RESPONSE TO REQUEST FOR ADDITIONAL INFORMATION

US-APWR Design Certification

Docket No. 52-021

RAI NO.: NO. 1025-7092 REVISION 3
SRP SECTION: 03.07.02 – Seismic System Analysis
APPLICATION SECTION: 3.7.2
DATE OF RAI ISSUE: 04/29/2013

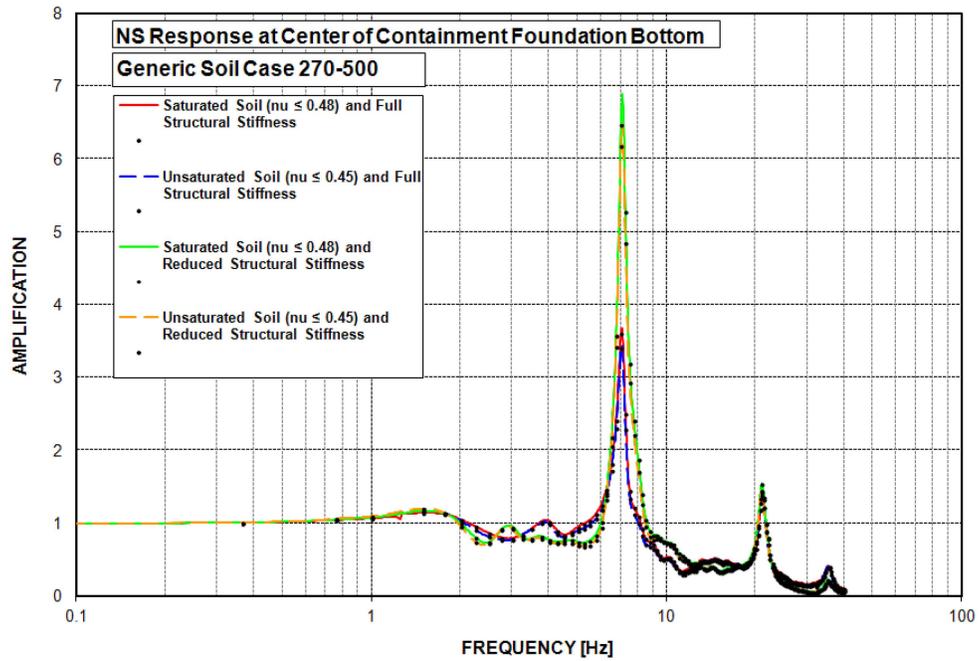
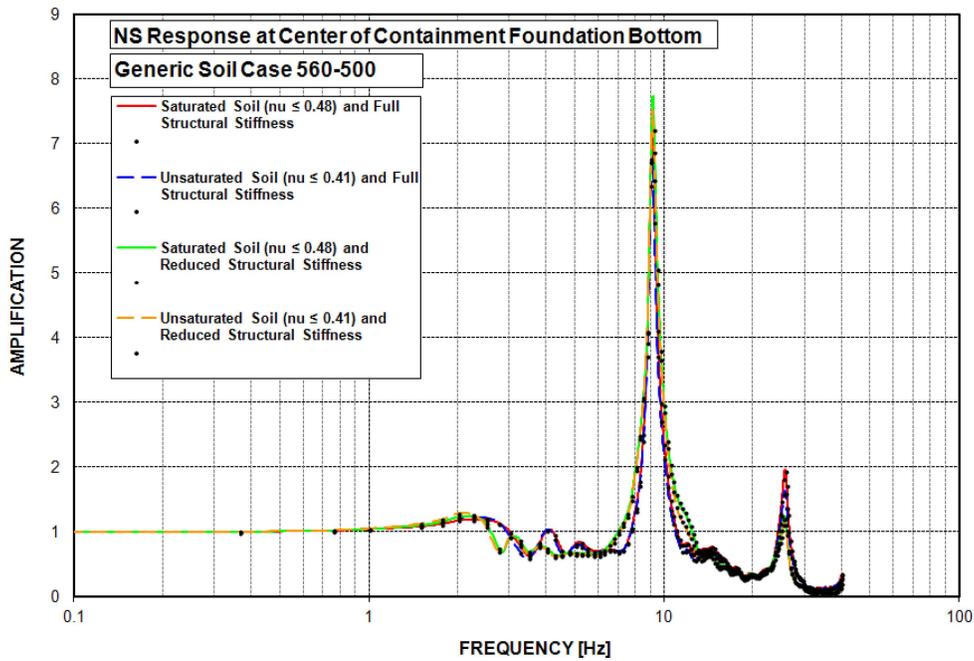
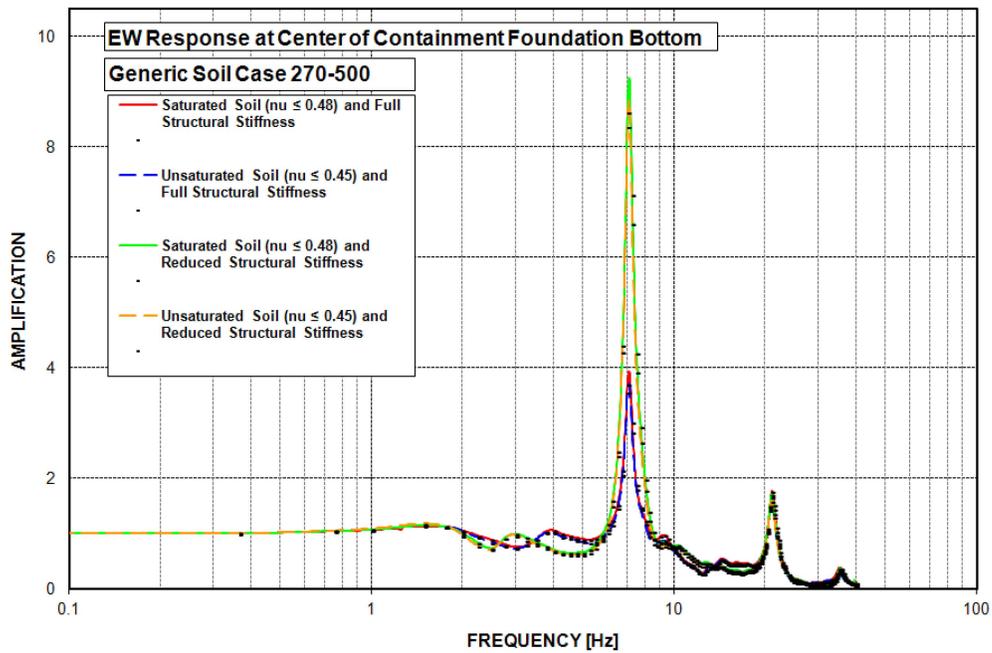
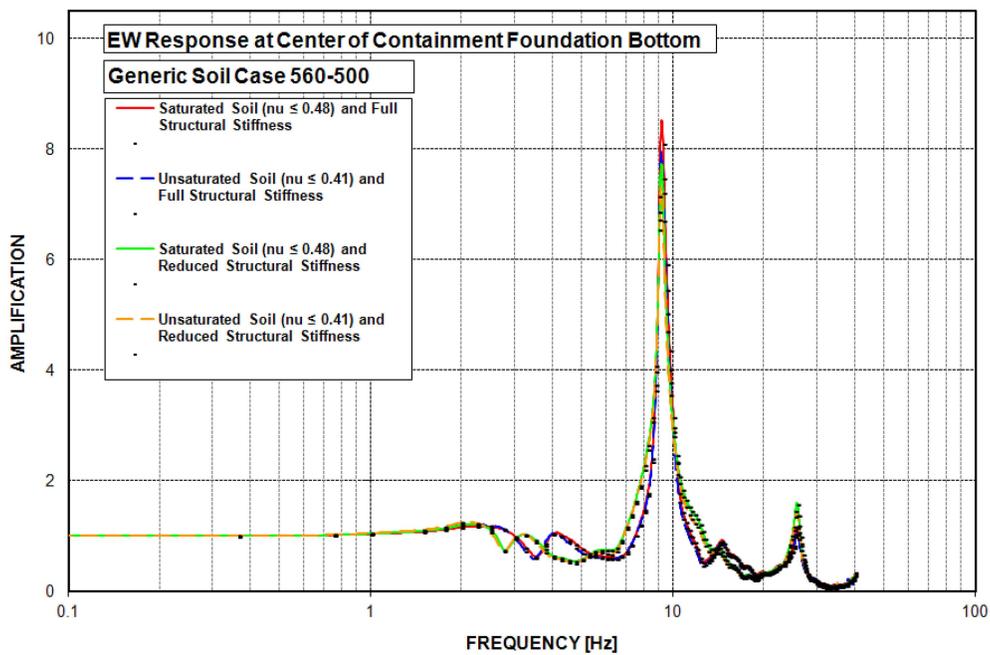
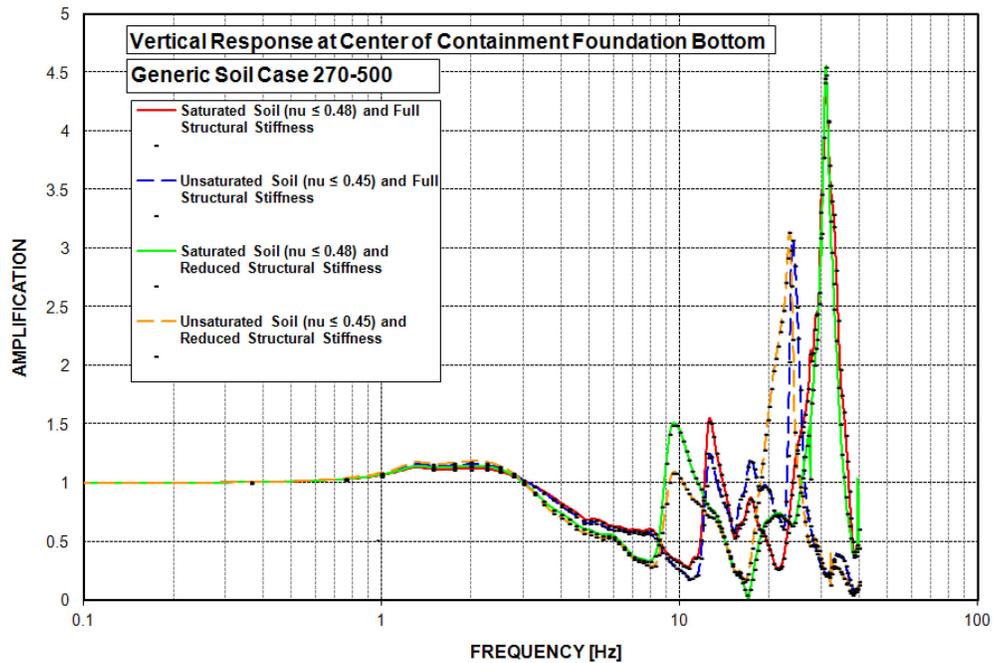
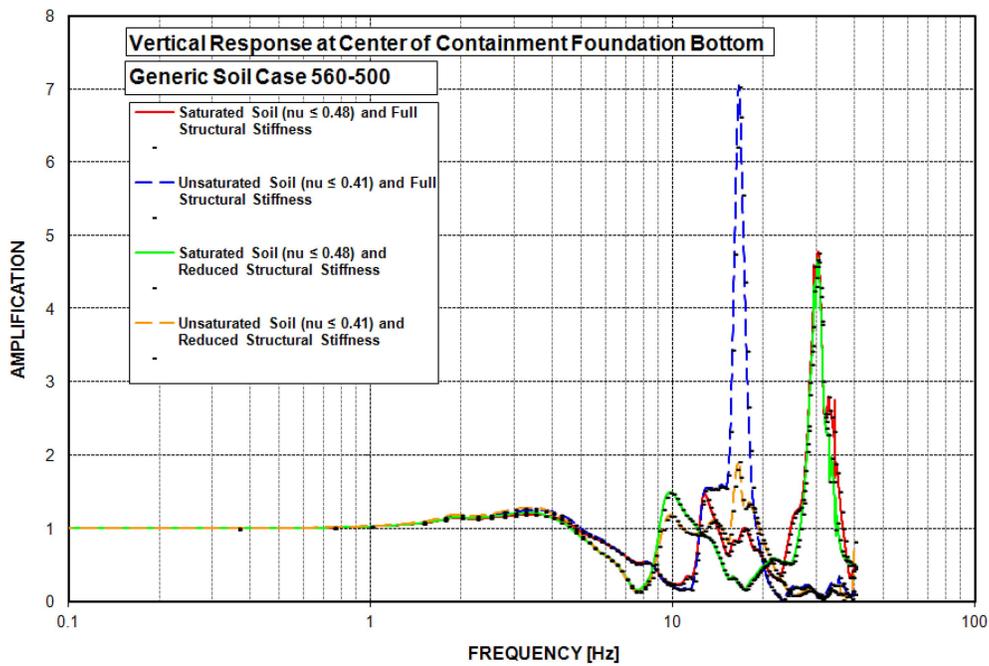
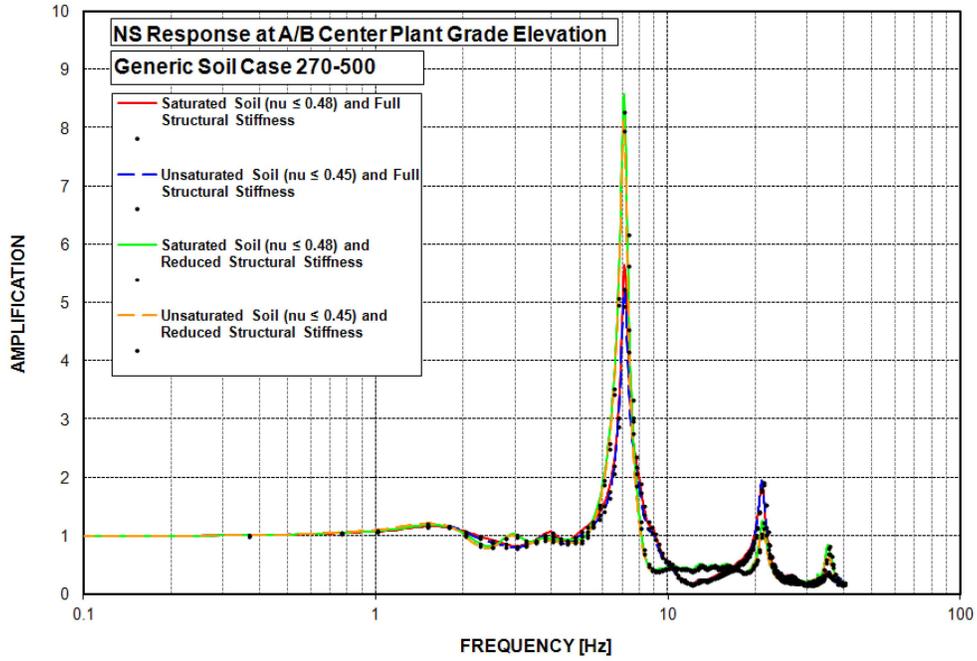
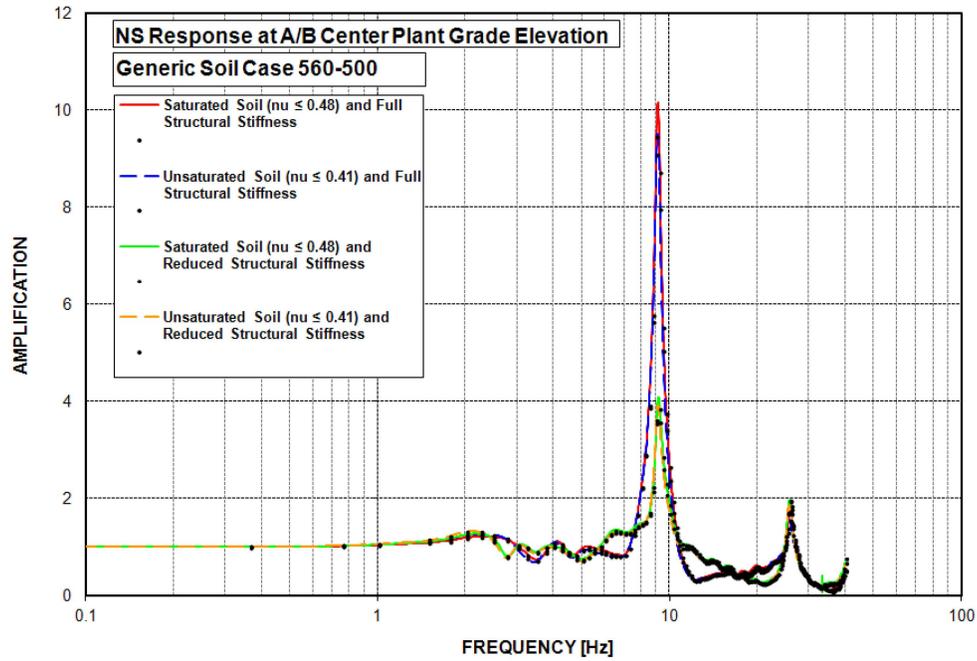
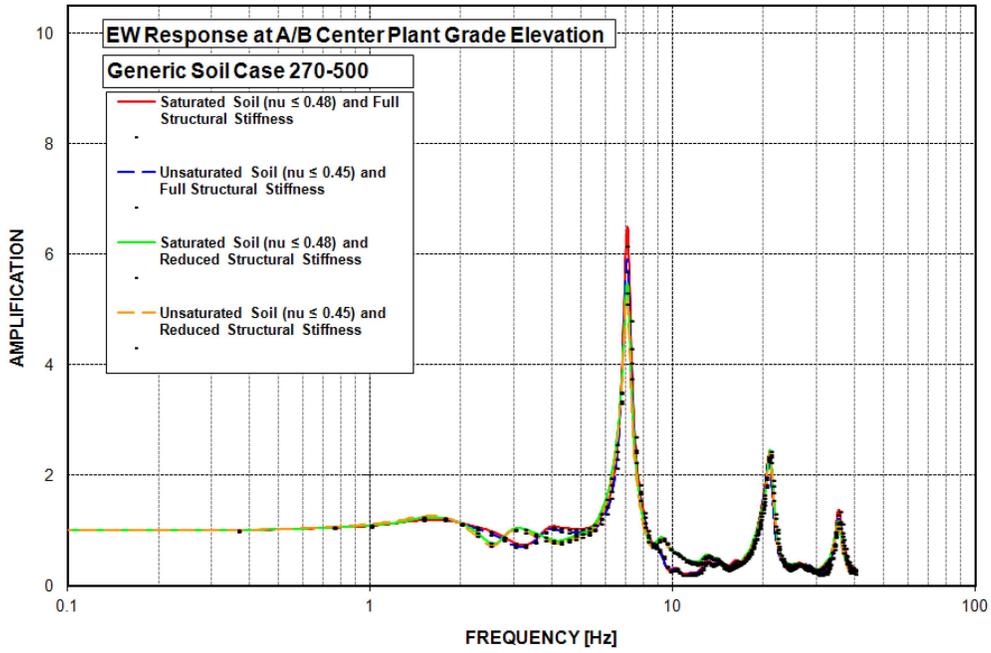
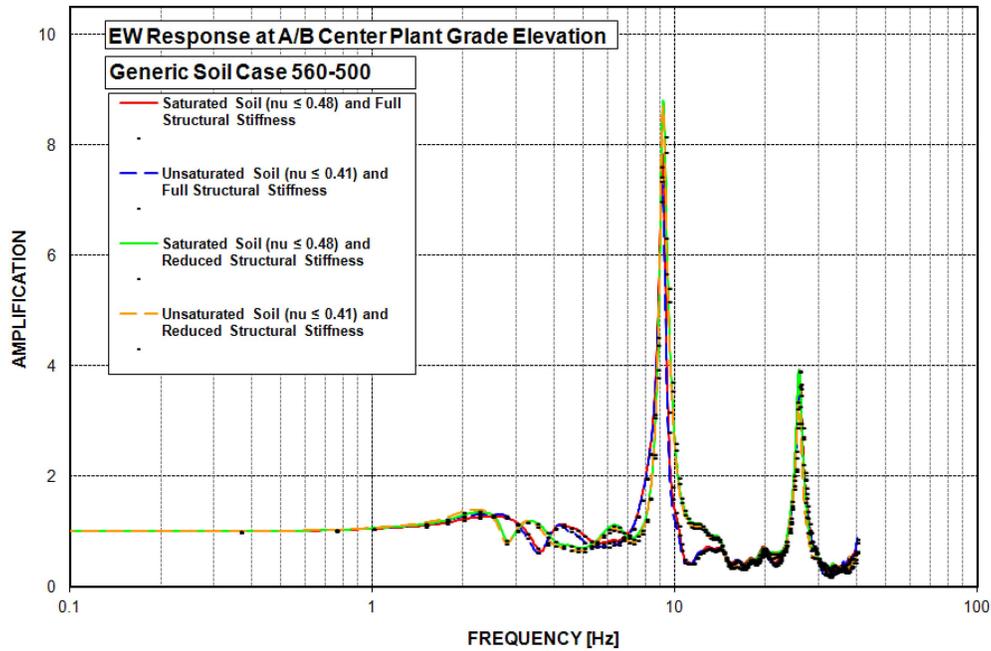
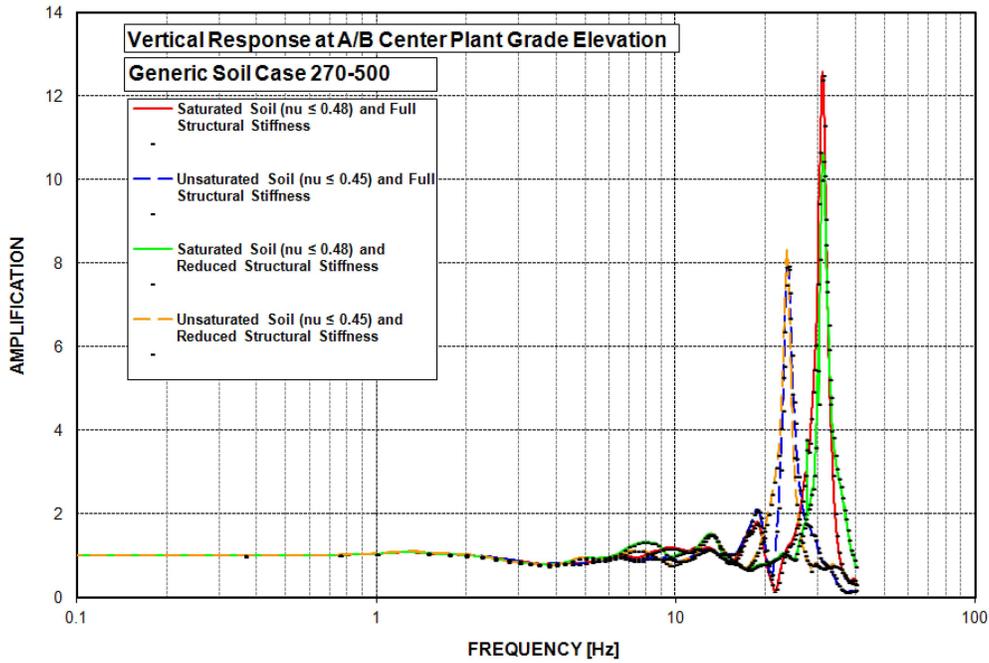
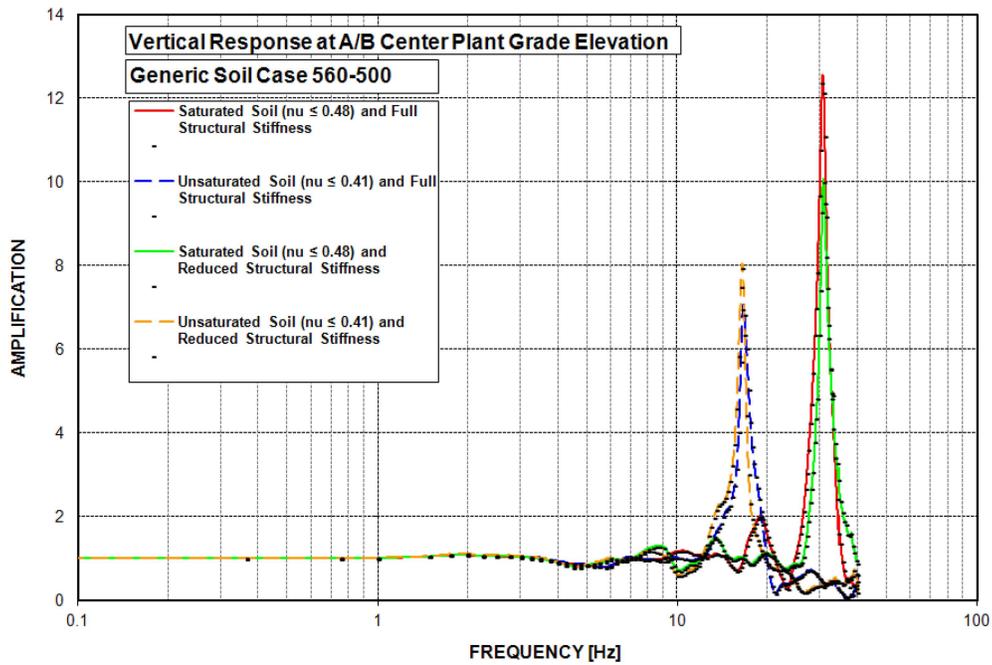
Section 2.3 of MUAP-11007 (R2) indicates that the Poisson's ratio used in developing the Pwave velocity of the saturated soil profiles approaches values close to 0.48, and that this value is low enough "not to compromise the numerical stability of the SASSI results."

The applicant is requested to provide (i) the basis for concluding that the numerical stability of the SASSI results is not compromised and (ii) the details of any specific sensitivity study that show that the ACS-SASSI results for APWR SSI analysis are numerically stable for the selected site-independent soil profiles and the assumed values of Poisson's ratio.

Figure 1 through Figure 12 below present comparisons of transfer functions results for the response of the Reactor Building (R/B) complex and Auxiliary Building (A/B) in the direction of the applied control motion for saturated generic profiles 270-500 and 560-500 and unsaturated generic profiles 270-500Dry and 560-500Dry. Transfer function results obtained from the SSI analyses of structural models with full and reduced stiffness properties are presented for two nodes, located at basemat bottom and plant grade elevations, where possible numerical instabilities in the SSI results due to high value of the soil Poisson ratio would be most apparent. Figure 1 through Figure 6 show the amplitude of the transfer functions at the center of the containment foundation bottom. Figure 7 through Figure 12 present transfer function results for the response at the center of the Auxiliary Building (A/B) basement at plant grade elevation. The interpolated transfer function results obtained from the SSI analyses of saturated and unsaturated profiles with higher and lower values of the soil Poisson ratio are shown with solid and dashed lines, respectively. The plots show the calculated values of the transfer functions with dots.

The figures show that the transfer function results do not indicate numerical instabilities in the results of the SSI analyses. The transfer functions obtained from SSI analyses of saturated profiles with a soil Poisson ratio approaching a value of 0.48 are very close and consistent with those obtained from the SSI analyses of unsaturated profiles with lower values of the soil Poisson ratio that remain below 0.45. The interpolated transfer functions are smooth curves without abrupt changes or spurious peaks, which indicates that no numerical instabilities exist.
